SHARP PLACE SUBDIVISION

APPLICATION NUMBER 9 DATE March 5, 2015

APPLICANT Sharp Place Subdivision

REQUEST Subdivision

DETAIL SITE PLAN

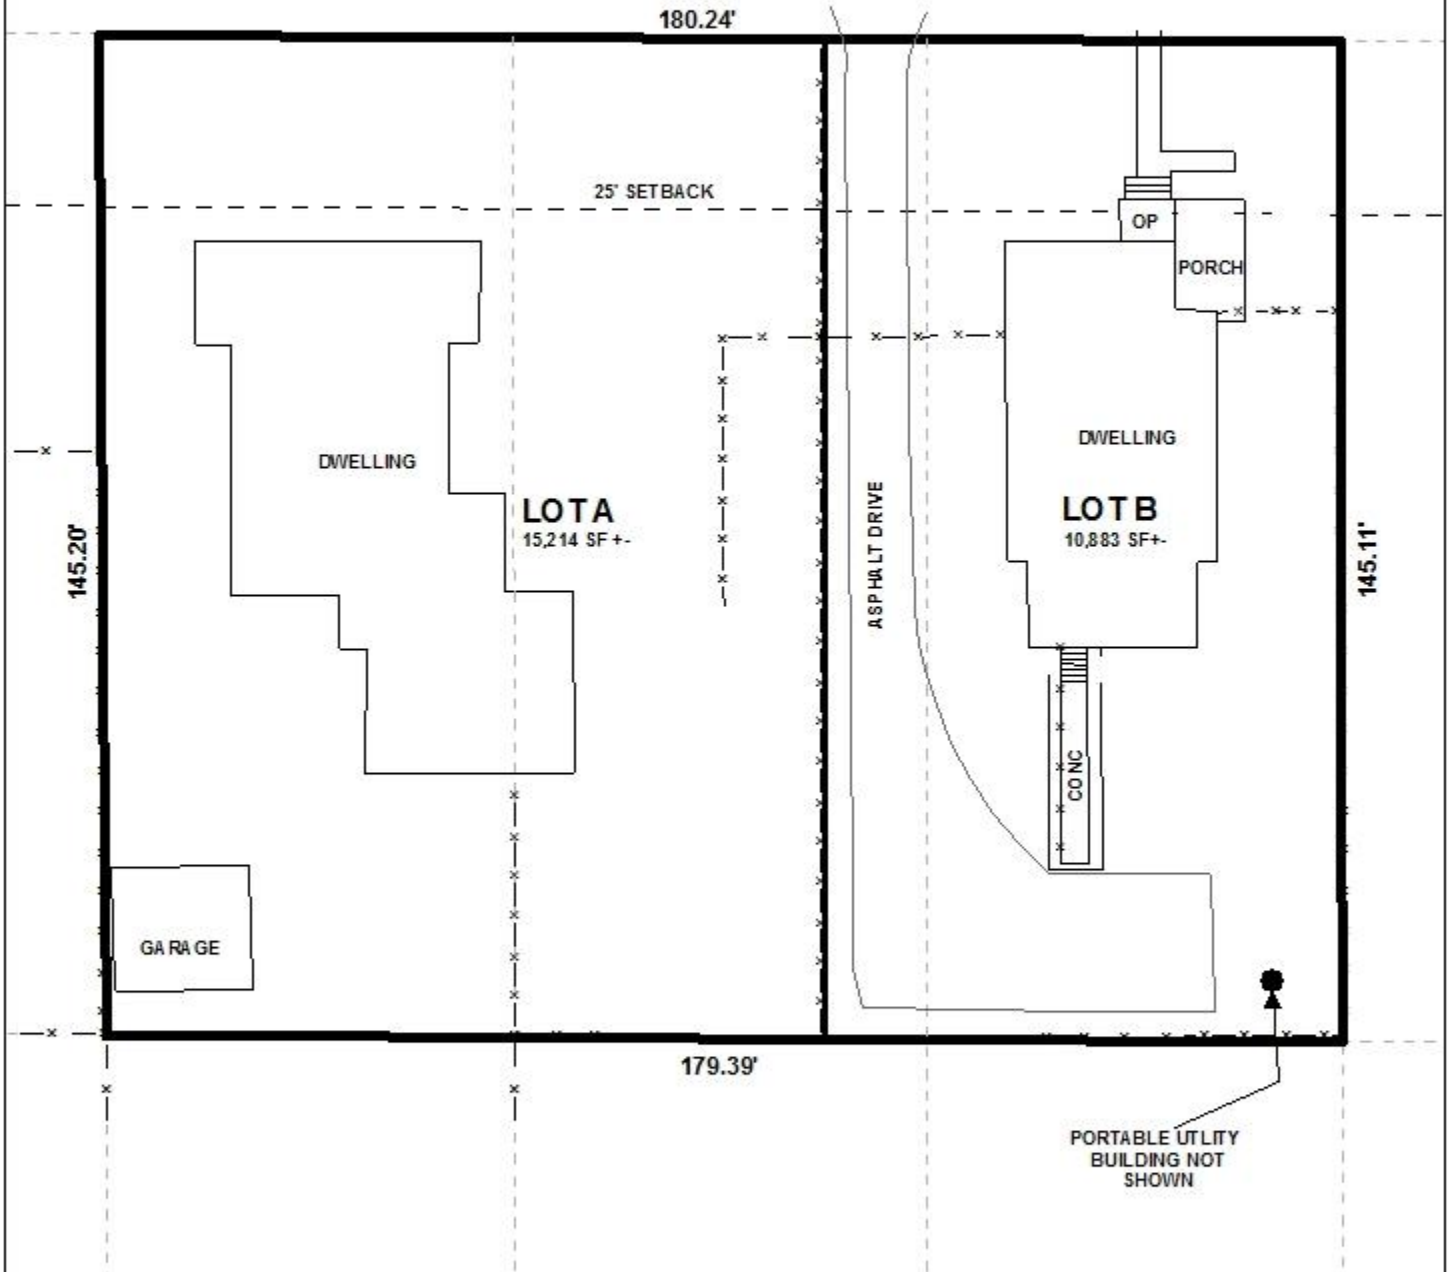
The site fronts onto The Cedars with a current substandard 40' right-of-way; therefore, dedication would be required to provide 25' from the centerline of The Cedars. As a means of access management, each lot should be limited to one curb cut to The Cedars, with the size, design and location to be approved by Traffic Engineering and conform to AASHTO standards.

Each lot meets the minimum area and width requirements of the Subdivision Regulations and the relocation of the common interior line would not create any Zoning Ordinance violations pertaining to side yard setbacks or site coverage. As on the preliminary plat, the Final Plat should also label each lot with its size in both square feet and acres, revised for any required frontage dedication, or a table should be furnished on the Final Plat providing the same information. The 25' minimum building setback line should also be illustrated on the Final Plat, revised to be measured from any required frontage dedication.

- 1) dedication to provide 25' from the centerline of The Cedars;
- 2) placement of a note on the Final Plat stating that each lot is limited to one curb cut to The Cedars, with the size, design and location to be approved by Traffic Engineering and conform to AASHTO standards;

- 3) retention of the labeling of each lot with its size in acres and square feet, revised for any required frontage dedication, or the furnishing of a table on the Final Plat providing the same information;

- 4) retention of the 25' minimum building setback line on each lot, revised to be measured from any required frontage dedication;
- 5) subject to the Engineering comments: *(The following comments should be addressed prior to submitting the FINAL PLAT for acceptance and signature by the City Engineer:*
